**SPADINA MUSEUM
GARAGE
REHABILITATION**
285 SPADINA ROAD TORONTO, ON

MECHANICAL TENDER ADDENDUM M-01

October 3, 2023

PROJECT: Spadina Museum Garage Rehabilitation and Site Accessibility
LOCATION: 285 Spadina Road, Toronto, ON M5R 2V5
Client Project #: A22048
M4S Project #: 22626

1 BOILER SCHEMATIC
SCALE: N.T.S.

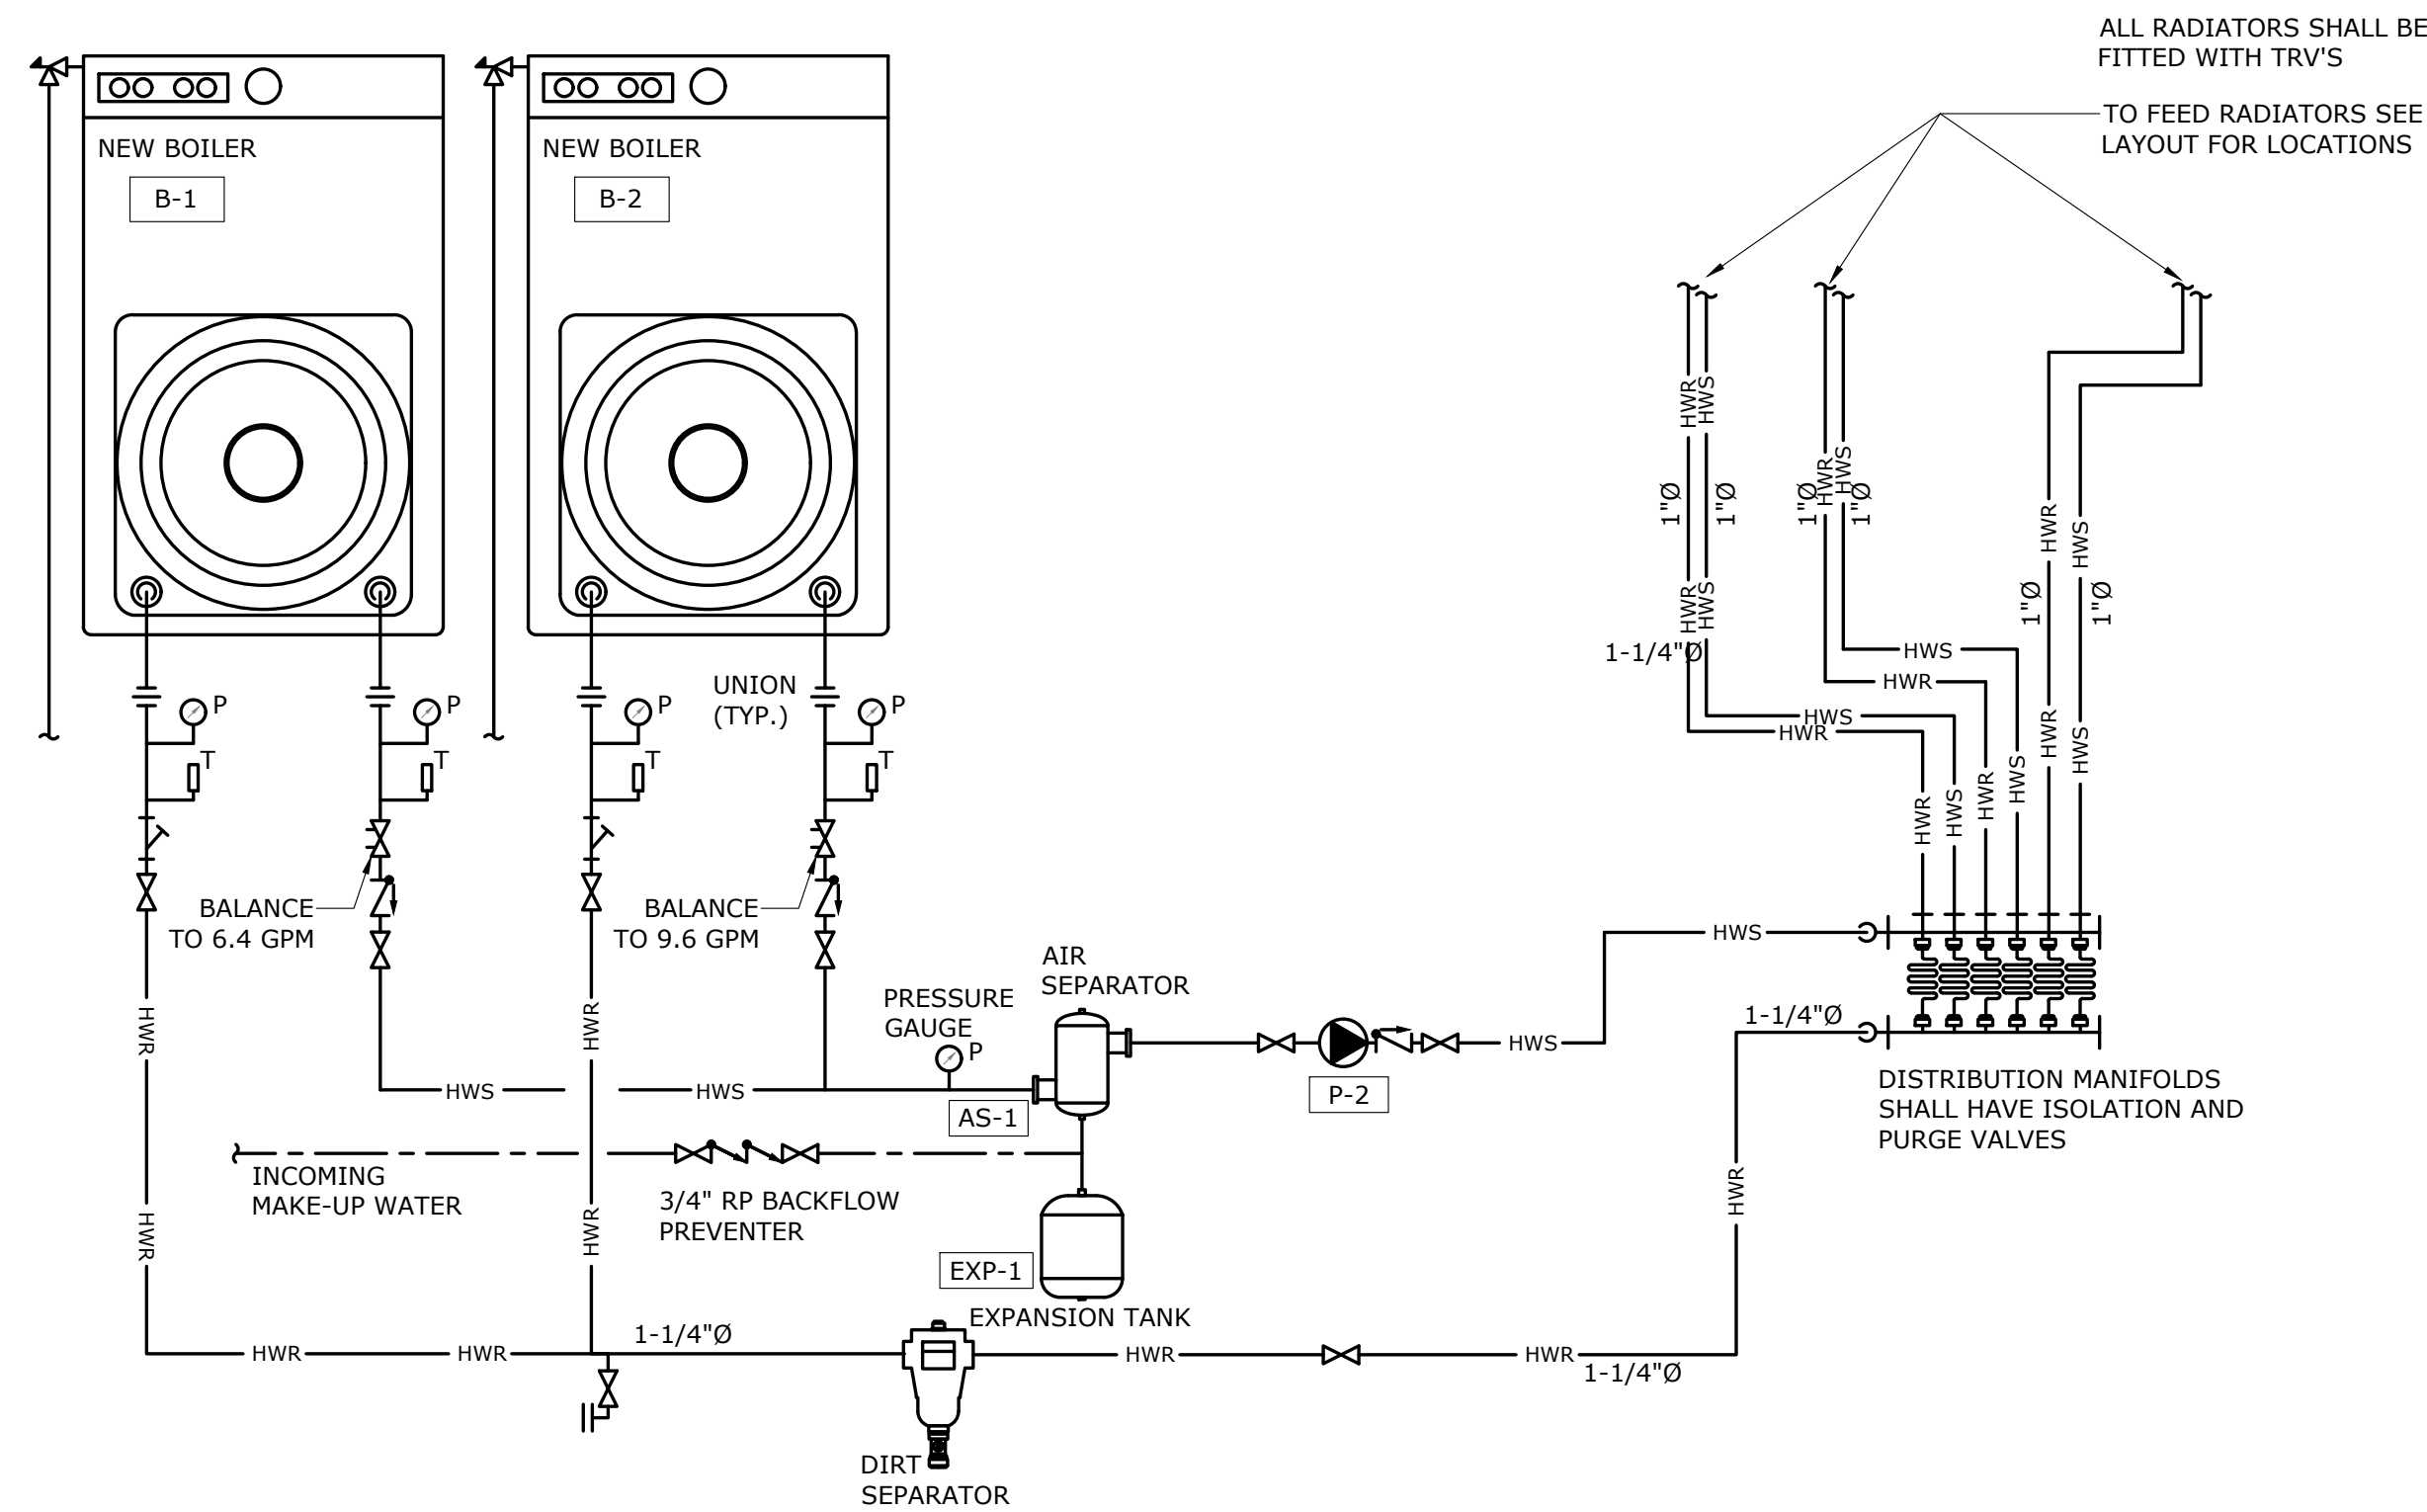
- Revision of the boiler schematic.

1 SITE PLAN - POWER & SYSTEMS - MODIFICATION
E-101 NTS

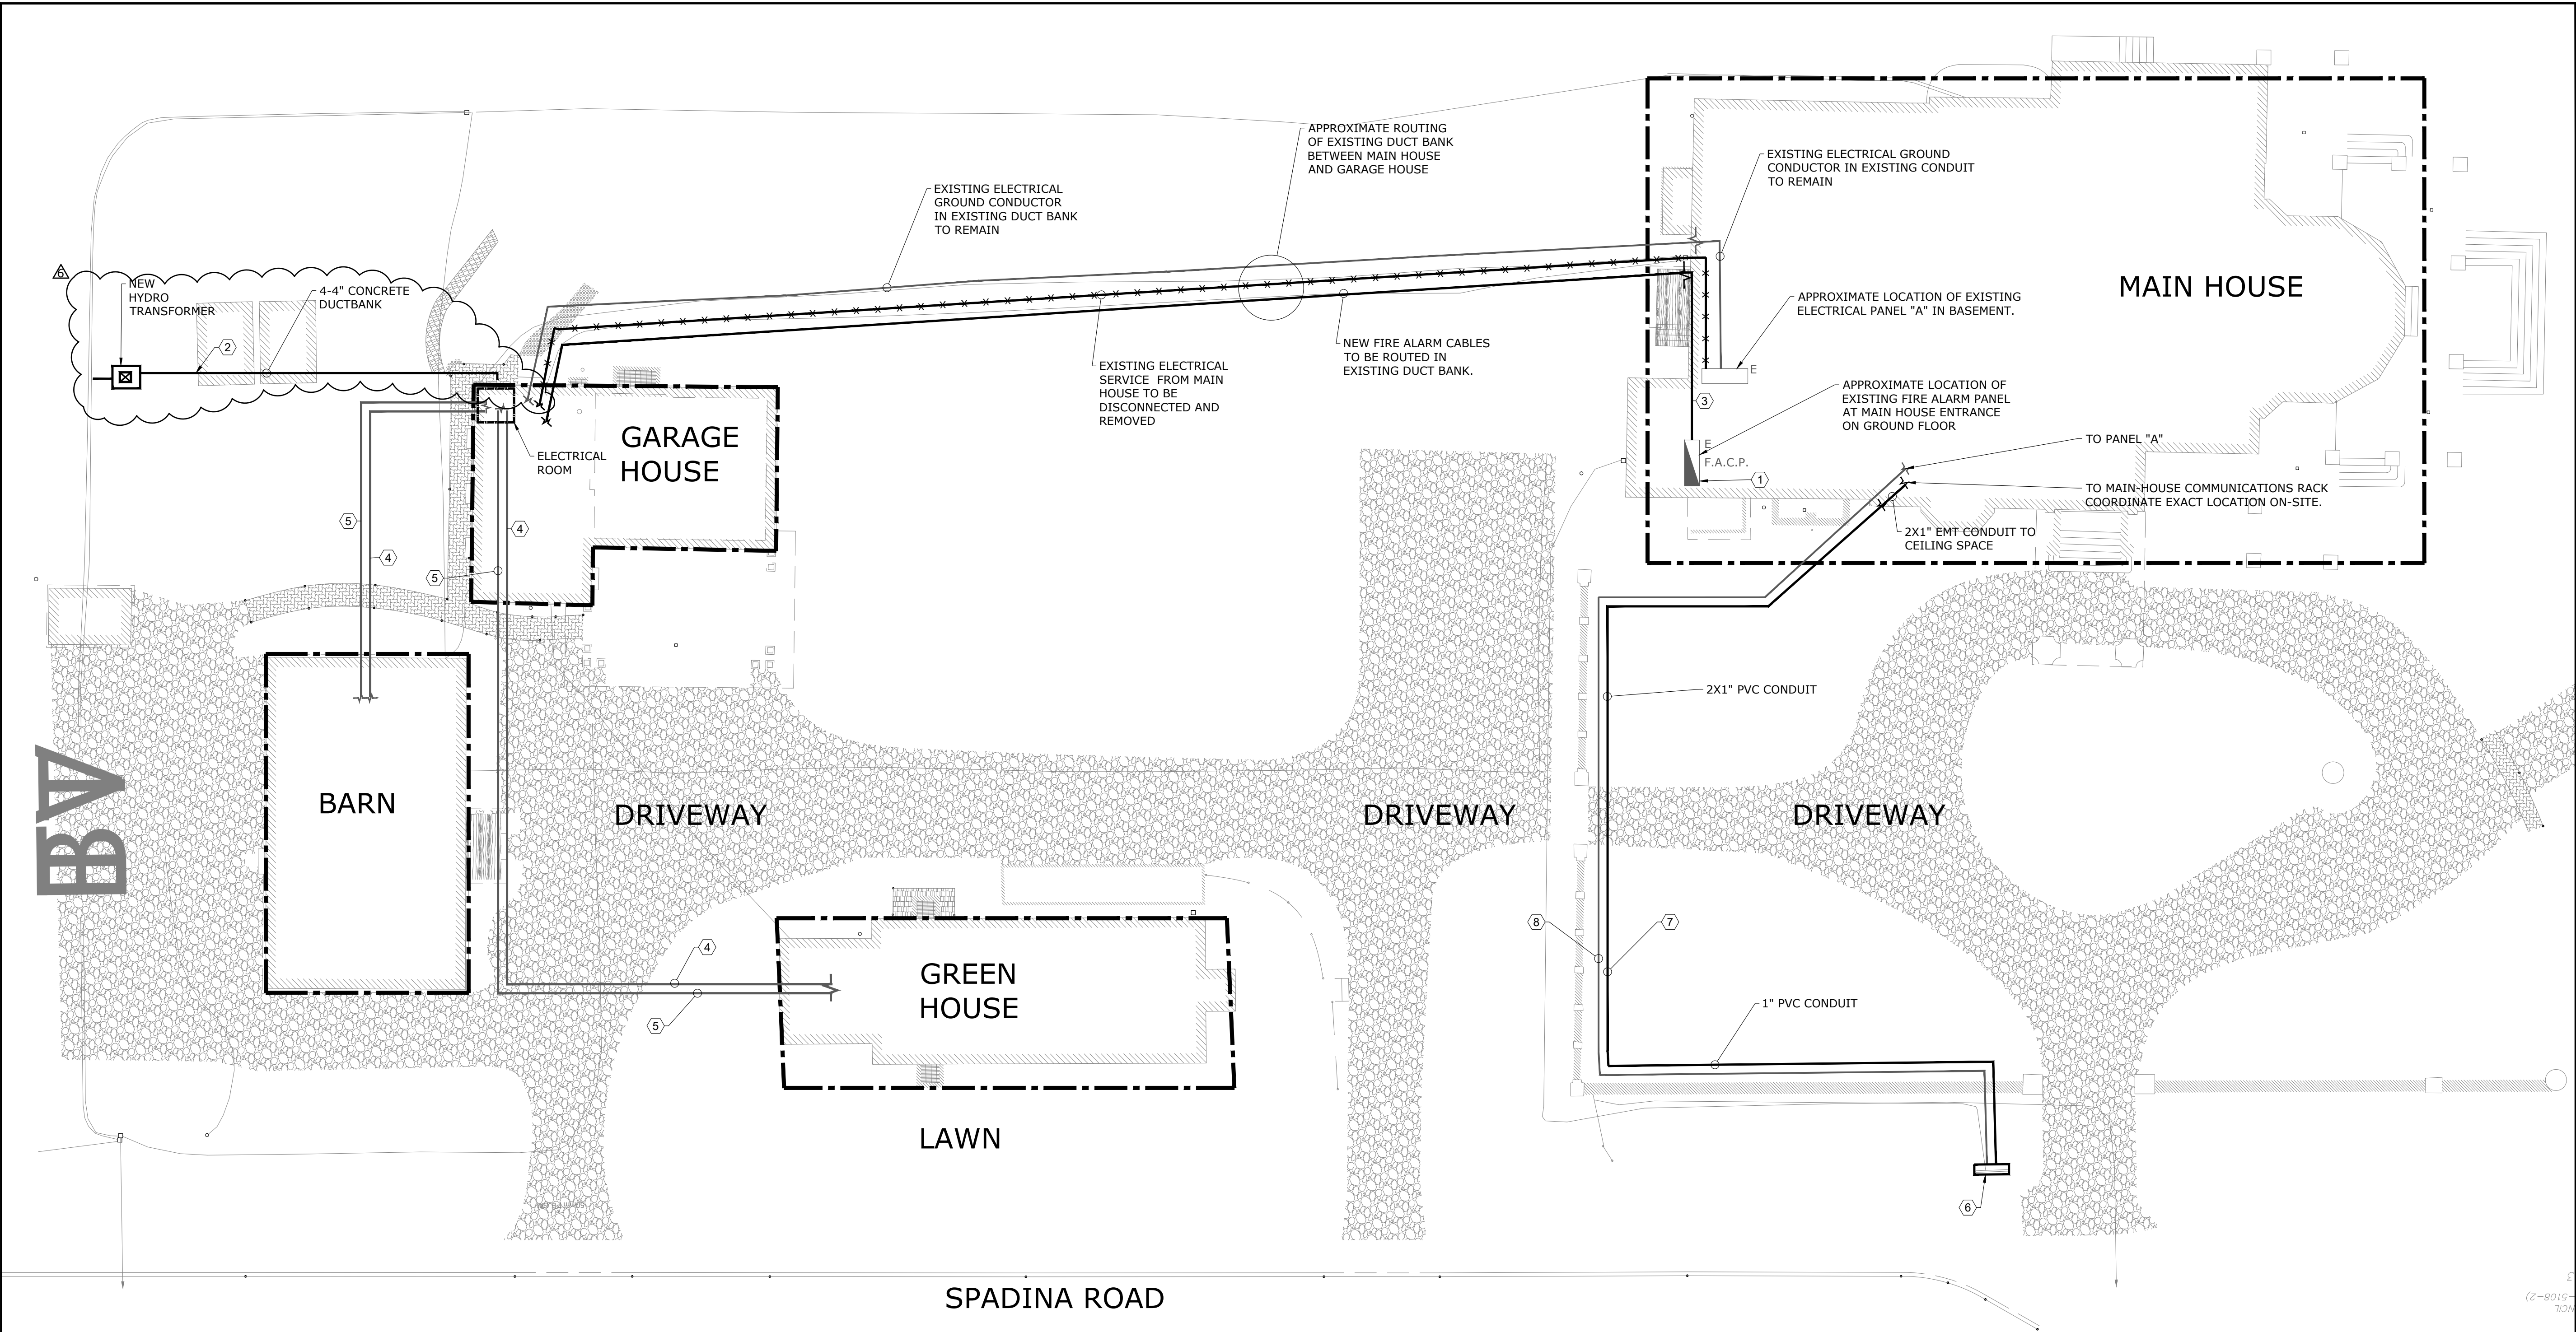
- **Dwg. E-101**
 - New Hydro padmount transformer, primary and secondary ductbanks shown.
 - Primary ductbank, pad for padmount transformer, padmount transformer and bollards to be supplied and installed by this contractor as per Hydro specifications and as per detail on Dwg. E-1001.

- Secondary ductbank specified and to be installed as per CSA 22.1-21.
 - **Dwg. E-200**
 - Detail 1/E-200
 - Reference note #1 added.
 - Detail 2/E-200
 - Reference note #1 added.
